Preliminary Stormwater Control Plan  
for  
Tract No. 1604  
547 Airport Blvd. Townhomes  
547 Airport Blvd.  
Watsonville, CA  
APN 015-321-01

## **Off-site Storm Water Analysis**

**Tract No. 1604  
547 Airport Blvd  
Townhouse Project**

**February 2021**

ROPER OFFSITE DRAINAGE SYSTEM MAP

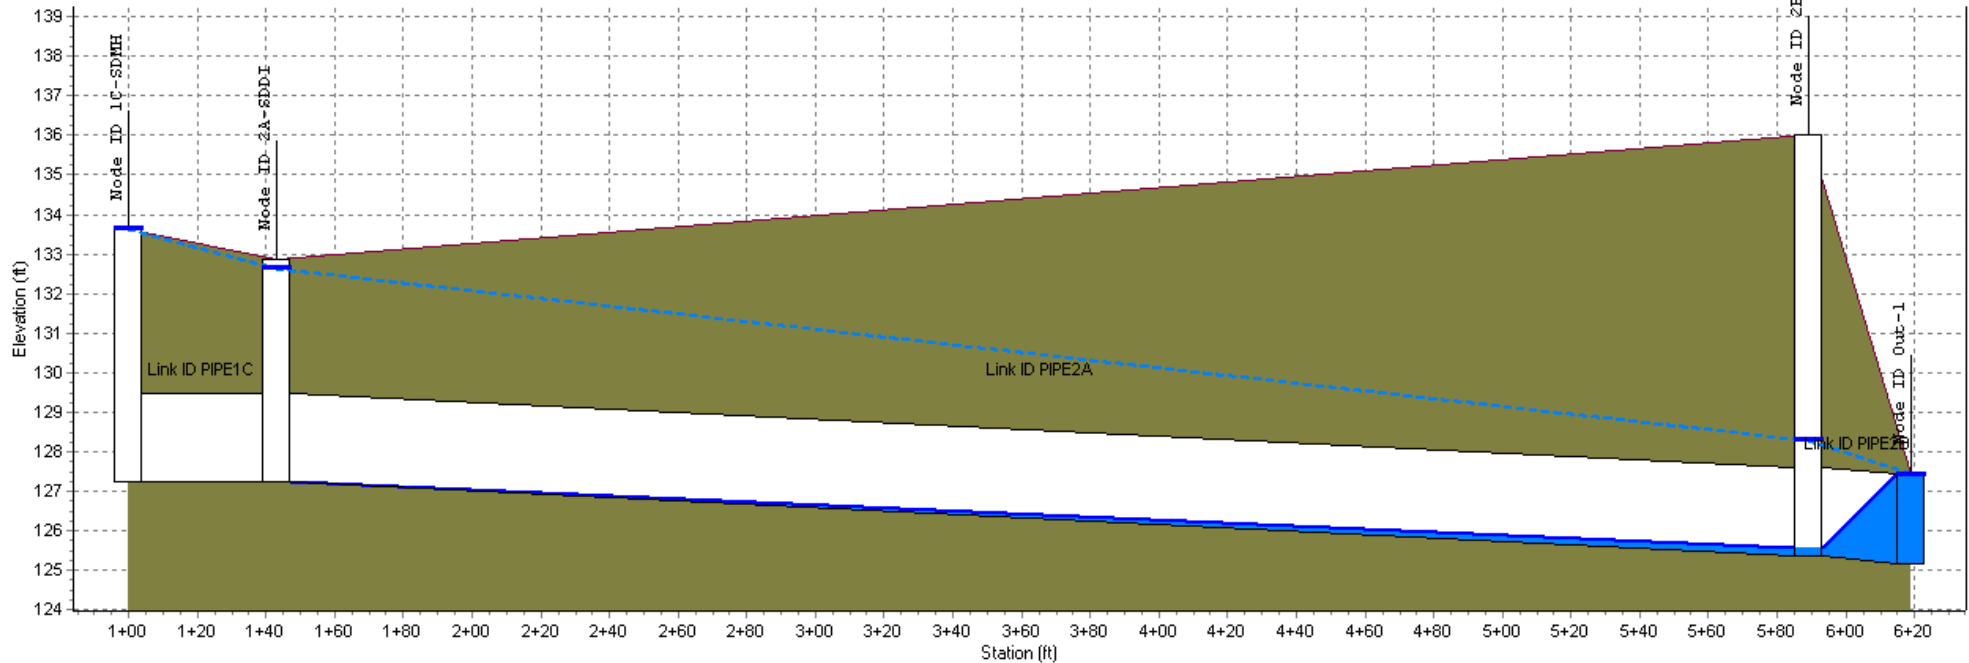
The analysis showed that the 27" pipe would surcharge and flooding would overflow from surface grates for the 25 year storm event. For this reason we are recommending modifications to the Roper plans to increase the detention pond to mitigate for both the 10 year storm and 25 year storm, and elimination of the proposed catch basin in Airport Blvd which would overload the site's proposed discharge pipe.

Tributary Area (ac)	Link(See Map in Appendix C Section 2)	Peak Flow (cfs)	Capacity (cfs)	Flow/Capacity	Condition
1.51	PIPE1A	1.07	14.46	0.07	SURCHARGED
2.04	PIPE1B	1.15	8.46	0.14	SURCHARGED
25.14	PIPE1C	25.36	1.29	19.59	SURCHARGED
25.14	PIPE2A	24.65	17.47	1.41	SURCHARGED
25.14	PIPE2B	24.65	20.79	1.19	SURCHARGED

The proposed Roper development would increase the peak flow to the already flooded system.

**MODIFIED OFFSITE DRAINAGE SYSTEM MAP**

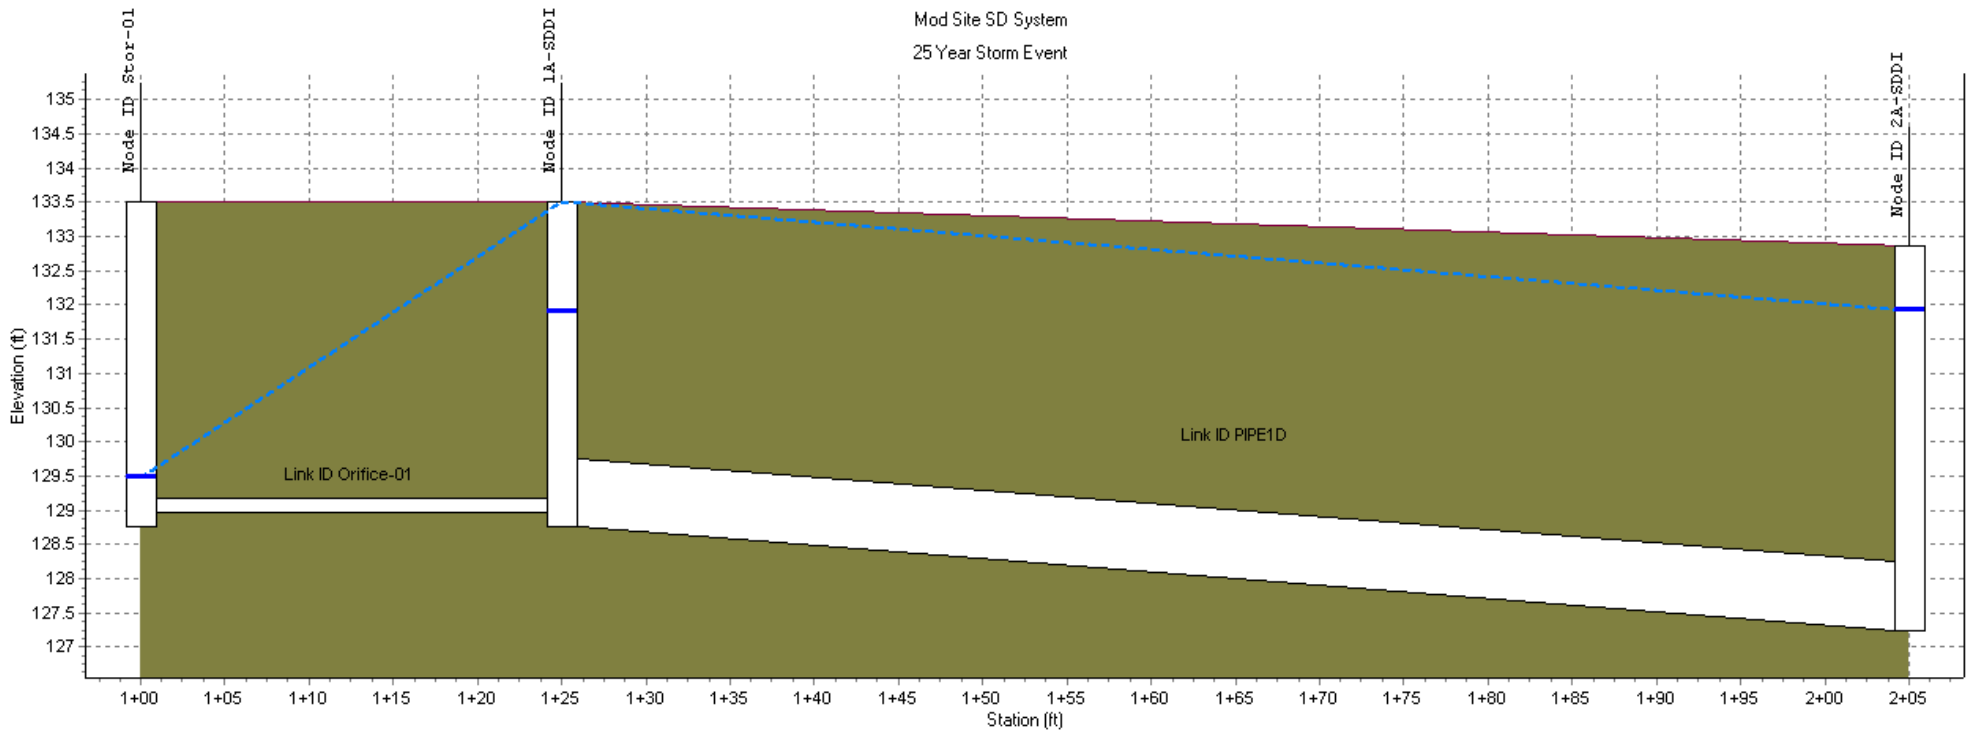
The modified proposed development would provide detention for the 25 year storm event with a release of the 10 year predevelopment flow rate (assuming a portion of the site drained to the rear of the site pre-development). The Modified system layout can be shown on the map in Appendix C The 25 year storm event flow results are as follows:

Tributary Area (ac)	Link (See Map in Appendix C Section 3)	Peak Flow (cfs)	Capacity (cfs)	Flow/Capacity	Condition
0.53	PIPE0A	0.92	10.42	0.09	SURCHARGED
0.53	PIPE0B	4.10	17.51	0.23	SURCHARGED
23.63	PIPE1C	23.17	1.29	17.90	SURCHARGED
1.51	PIPE1D	1.43	4.26	0.34	SURCHARGED
25.14	PIPE2A	22.91	17.47	1.31	SURCHARGED
25.14	PIPE2B	22.91	20.79	1.10	SURCHARGED

The modified design would prevent any additional flooding to the existing system for the 25 year storm event.

The modified detention volume for the site was determined using the County of Santa Cruz detention methodology for the 25- year 15 min storm event. To account for the redirection of flow the allowable pre-development flow is only for the existing 0.78 acres.

The resulting detention volume would need to be 3539 cf. Therefore we proposed to modify the existing bioretention design to provide storage in a gravel depth to 1.25 ft, include 2 ft of storage in the bioretention media, and provide 0.5 ft of ponding above the bioretention, resulting in 3750 cf of detention.
